Subject: Response to the Comment Letter from City of Menifee dated August 14, 2023 on the Mapes and Trumble Industrial Facility Project (Conditional Use Permit 22-05023)

The following are responses to the comment letter from the City of Menifee dated August 14, 2023, on the Final Initial Study/Mitigated Negative Declaration (IS/MND) for the Mapes and Trumble Industrial Facility Project (Conditional Use Permit 22-05023).

**FIGURE 1**

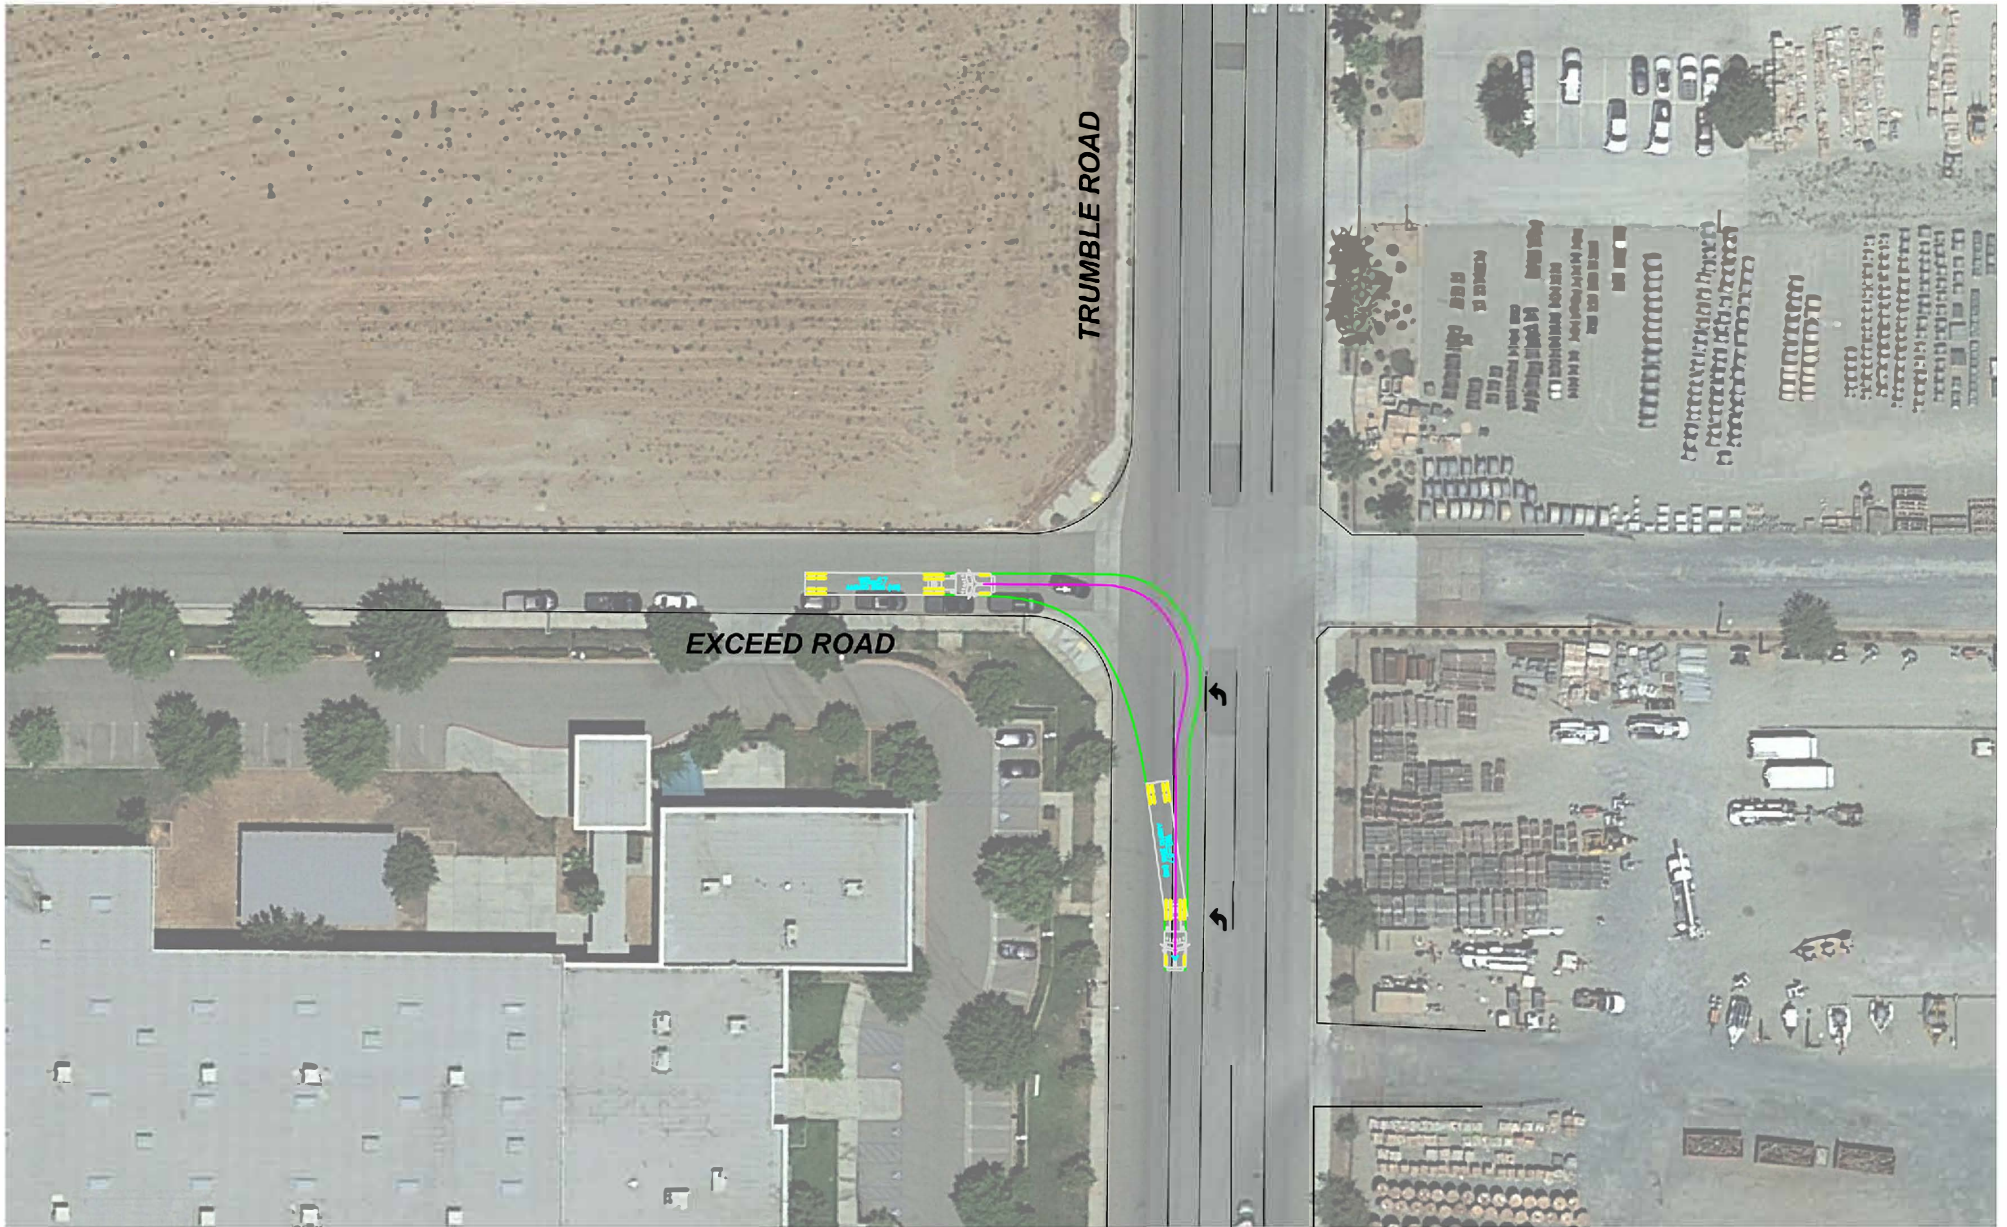
The comment states that the City of Menifee advises the re-evaluation of the intersection design, and width, at "Exceed Road" and "Trumble Road," to the west of Trumble Road. The schematics provided in the TIA show the truck turning movements from eastbound Exceed Road to South Bound Trumble Road significantly crossing over the median, striking cars queued to turn left from northbound Trumble Road to westbound Exceed Road. The right turn from eastbound Exceed Road to South Bound Trumble also would only work if there was "no parking" on Exceed Road, and trucks would still likely encroach onto the Americans with Disabilities Act ramp and encroach onto the northbound Trumble Lane. The proposed geometrics would result in an unsafe condition at the intersection.

- The City advises the re-evaluation of the intersection design, and width, at “Exceed Road” and “Trumble Road,” to the west of Trumble Road. The schematics provided in the TIA show the truck turning movements from east-bound Exceed Road to South Bound Trumble Road significantly crossing over the median, striking cars queued to turn left from north-bound Trumble Road to west bound Exceed Road. The right turn from east-bound Exceed Road to South Bound Trumble also would only work if there was “no parking” on Exceed Road and trucks would still likely encroach onto the Americans with Disabilities Act ramp and encroach onto north-bound Trumble Lane. The proposed geometrics would result in an unsafe condition at the intersection.

**Response:** There is no designated provision for on-street parking along either side of Exceed Road, west of the intersection of Trumble Road/Exceed Road-Sturgeon Electric Driveway. Exceed Road is a local road with the purpose of serving land uses and projects along its northern and southern frontage, west of Trumble Road. The project site is zoned as BP-Business Park, which is expected to generate truck traffic. The primary purpose of Exceed Road is to accommodate passenger vehicle and truck traffic generated by the projects along its frontage. Therefore, it is expected to prioritize the truck ingress and egress traffic rather than provision for vehicular on-street parking. As such, removal of on-street parking from spaces not designated for on-street parking does not constitute any significant and unavoidable impact. Further, it has been stated in the TIA that the existing provision (unofficial) for on-street parking needs to be removed for the truck movements.

Additionally, egress truck traffic turning radii adequacy for trucks turning south into Trumble Road from Exceed Road have been reevaluated as shown on the attached Figure 1. As shown on Figure 1, these trucks do not cross over the median or create any potential safety hazard for cars queued to turn left from northbound Trumble Road to

westbound Exceed Road. Additionally, trucks would not encroach onto the Americans with Disabilities Act ramp or encroach onto northbound lanes along Trumble Road.
